Subject: EES comments on Modification application for Spring Farm Quarry – extension of time (DA75/256 MOD 5) – 186 Macarthur Road, Spring Farm

Attachment A**Subject: EES comments on Modification application for Spring Farm Quarry – extension of time (DA75/256 MOD 5) – 186 Macarthur Road, Spring Farm**

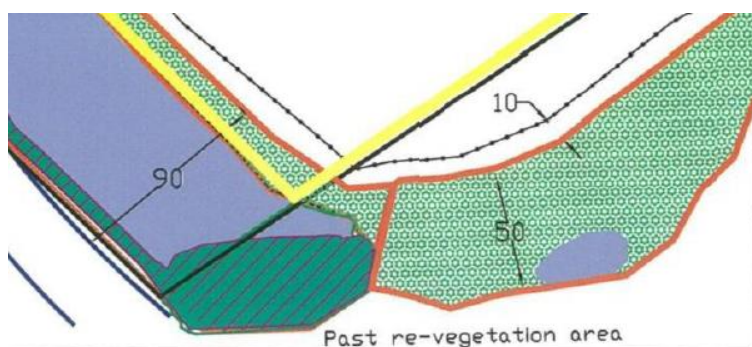
Figure 31 in the EA also appears to show widths of the revegetation areas. The RtS needs to clarify if the numbers shown are the widths of the planted areas in metres. For example, is the riparian linkage meant to be 50 m wide at the location shown below:
